Ltr submitting changes to their 9-20-74 request for change to tech specs.....

PLANT NAME: Oconee #1

Re: Oconee Unit 1  
Docket No. 50-269

REPLACEMENT PAGES FOR  
BABCOCK AND WILCOX REPORT 1409

Figure 3-5 Control Rod Group Withdrawal Limits  
for Four Pump Operation

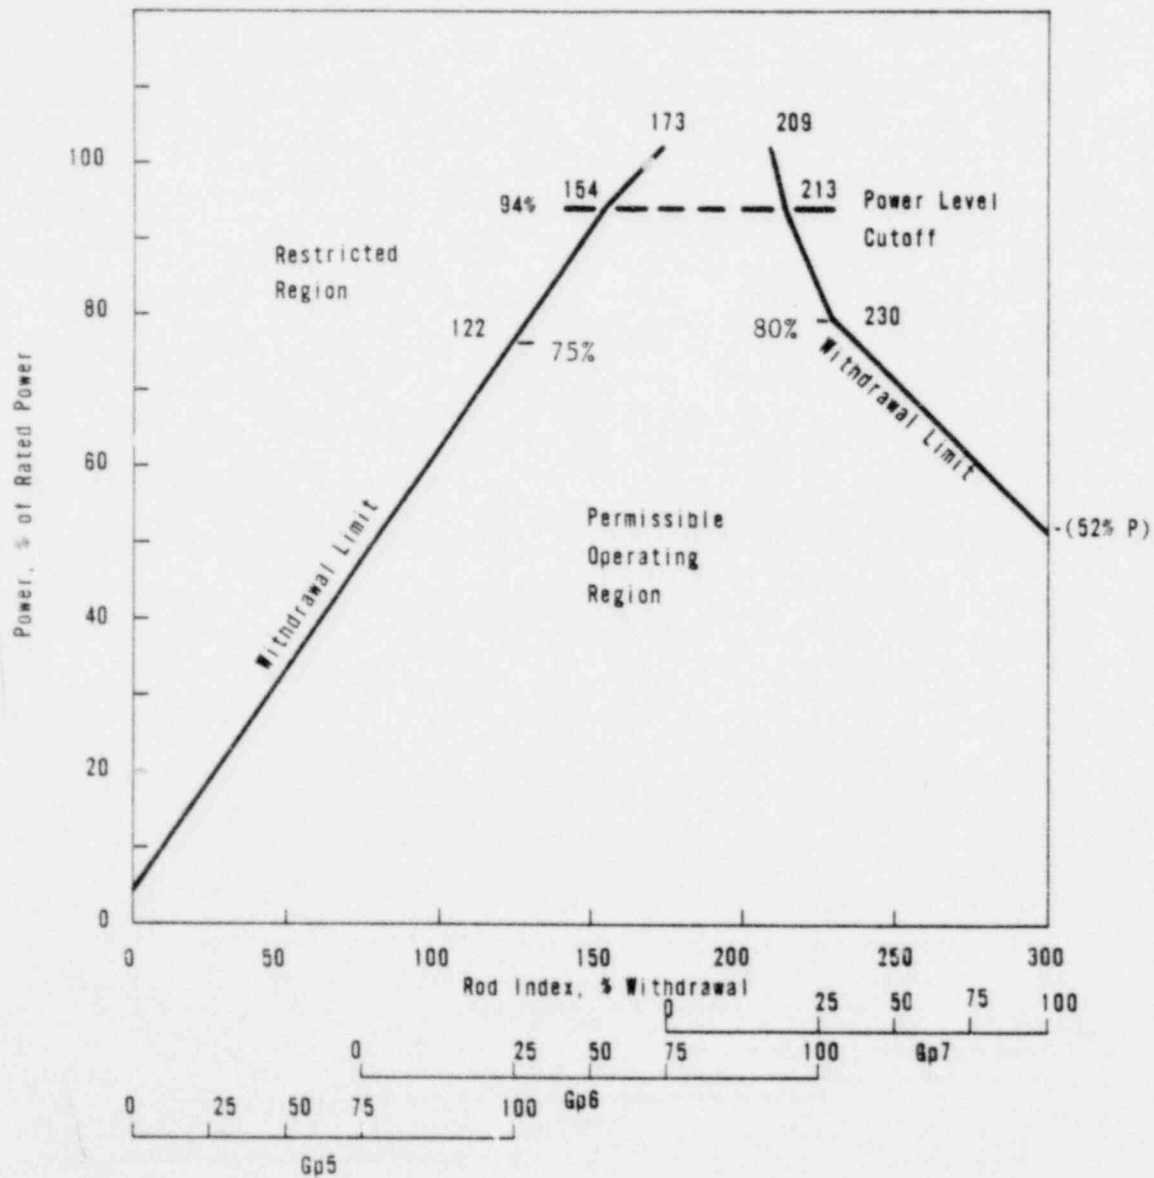
1. Rod index is the percentage sum of the withdrawal of the operating groups.
2. The withdrawal limits are modified after  $250 \pm 5$  full power days of operation.

Figure 3-6 Control Rod Group Withdrawal Limits  
for Four Pump Operation

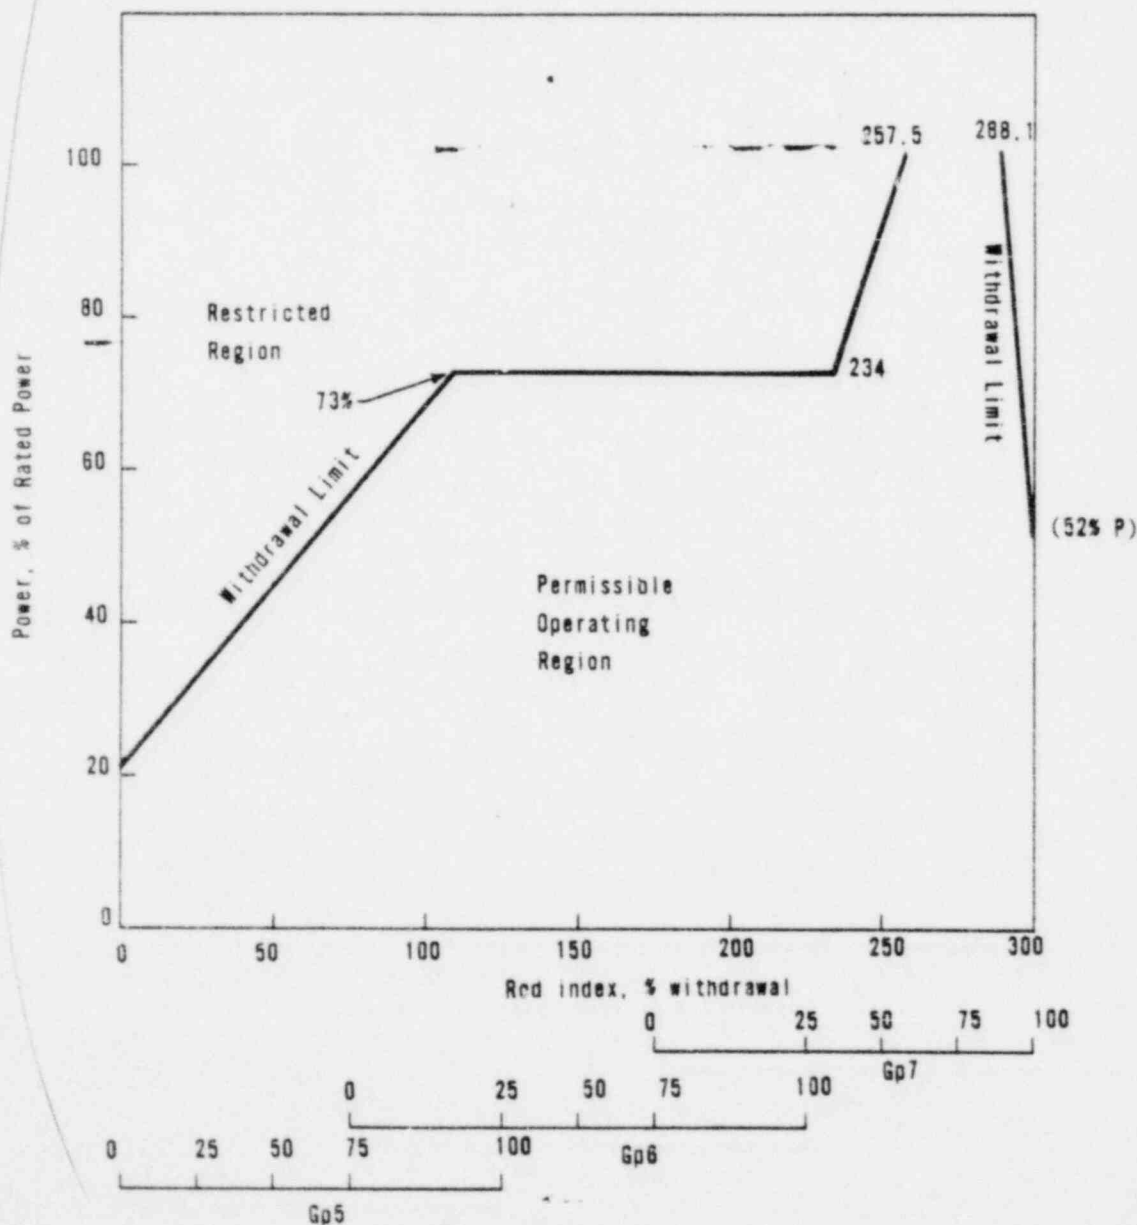
1. Rod Index is the percentage sum of the withdrawal of the operating groups.
2. The withdrawal limits are in effect after  $250 \pm 5$  full power days of operation. (The applicable power level cutoff is 100% power)

Figure 3-7. Control Rod Group Withdrawal Limits for Three- and Two-Pump Operation

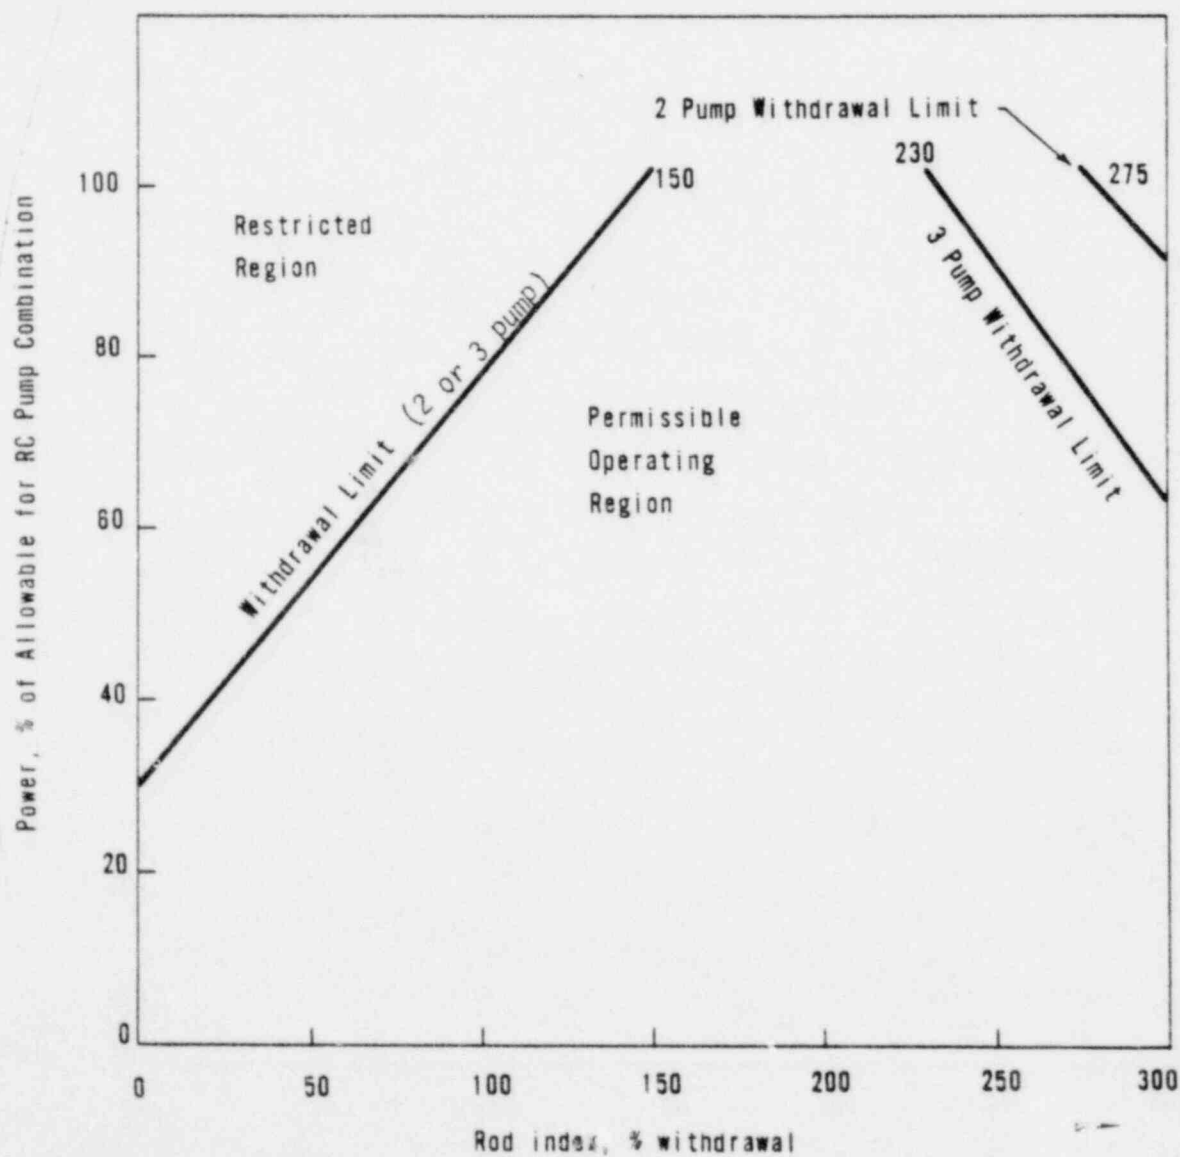
1. Rod index is the percentage sum of the withdrawal of the operating groups. (The applicable power level cutoff is 100% power)
